**Wickenburg Downtown Flooding Hazard
Mitigation Project
(FCD #2006C018)**

Letter of Map Revision (LOMR)

FEMA Case No. 11-09-3523P

LETTER OF MAP REVISION DETERMINATION DOCUMENT

Sheet 2 of 10

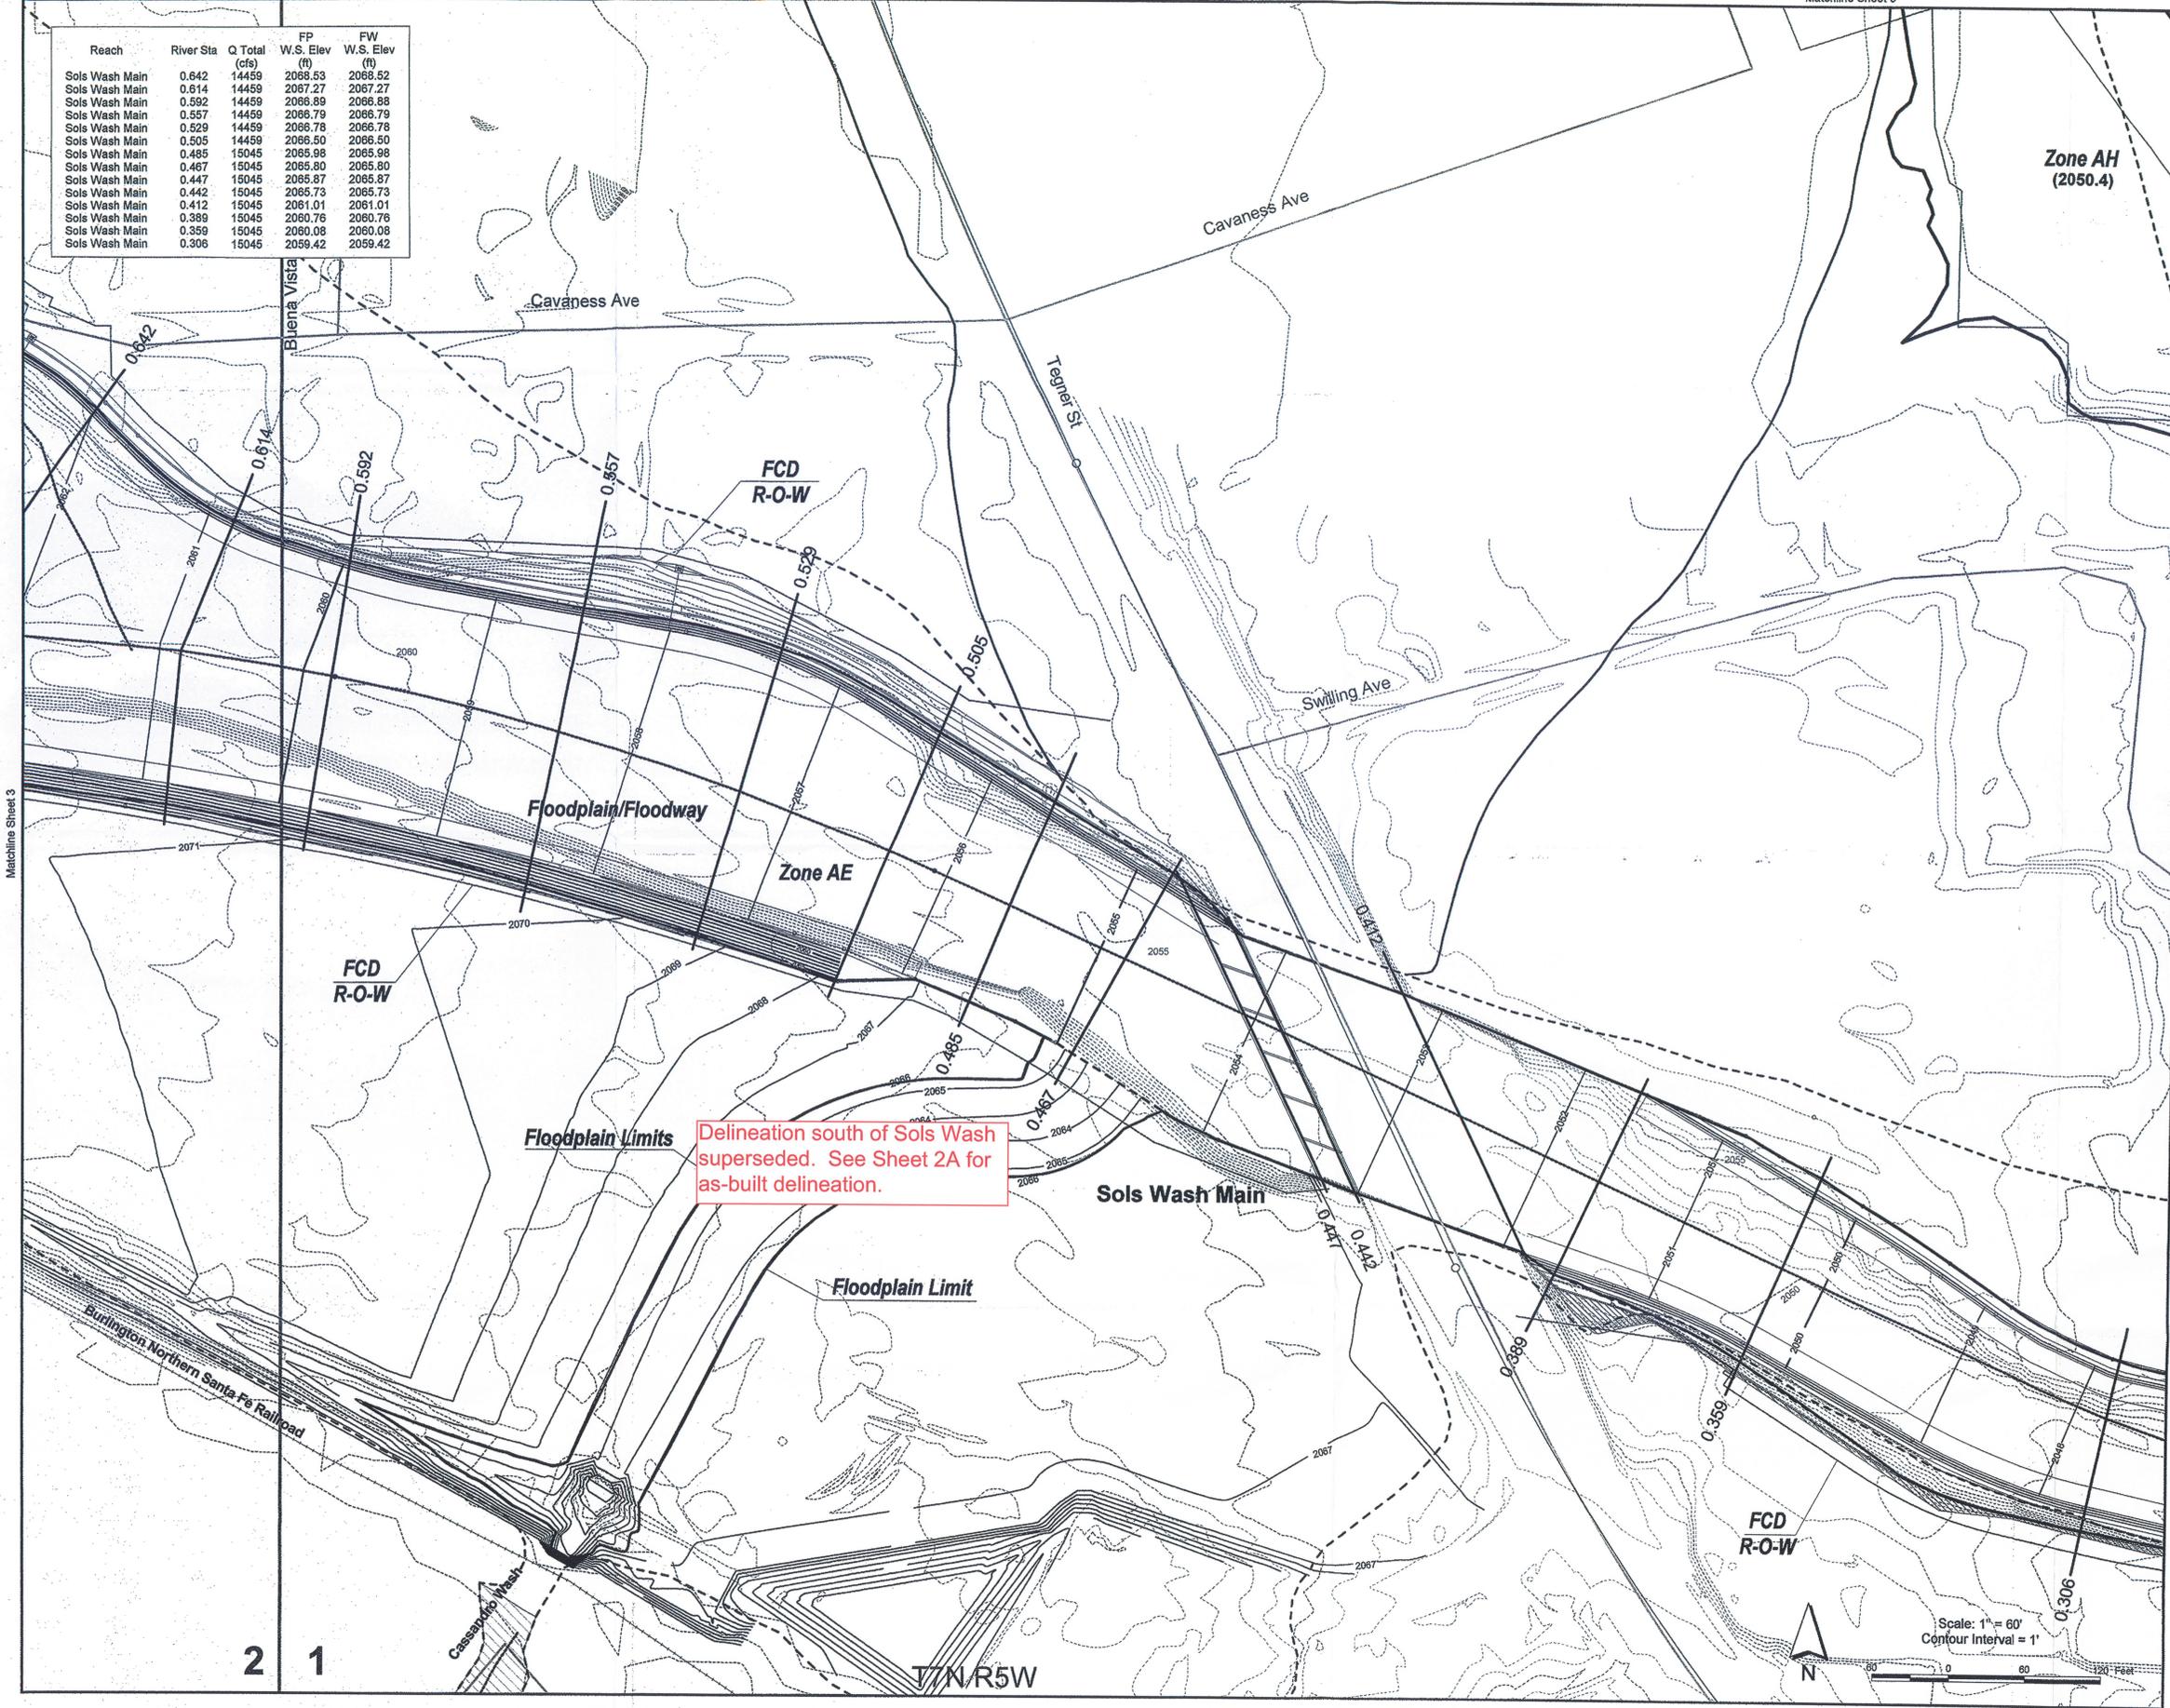
- The delineation on the south side of Sols Wash on work map sheet 2 was revised to reflect the as-built grading which included a wider channel for Casandro Wash than the original design. The revised delineation is shown on revised work map sheet 2A.
- The HEC-RAS hydraulic models for both Sols and Hospital Washes were renamed to include "LOMR" in the project name so as to identify the models as the as-built conditions LOMR models. No changes were made to the models themselves.
- The CLOMR included a re-delineation of Hospital Wash. Since the CLOMR, minor revisions were made to the floodplain delineation between HEC-RAS cross sections to better match the topographic contours. As well, minor refinements were made to the floodway to obtain a more

Delineation south of Sols Wash superseded. See Sheet 2A for as-built delineation.

- 4) *LOMR Work Maps:* The work maps for Sols Wash remain the same as submitted for the CLOMR. For Hospital Wash, the work maps have been revised between cross sections to better match the contours of the final topographic mapping. The floodplain for Casandro Wash (south of Sols Wash) was modified on work map sheet 2A to match the as-built conditions.
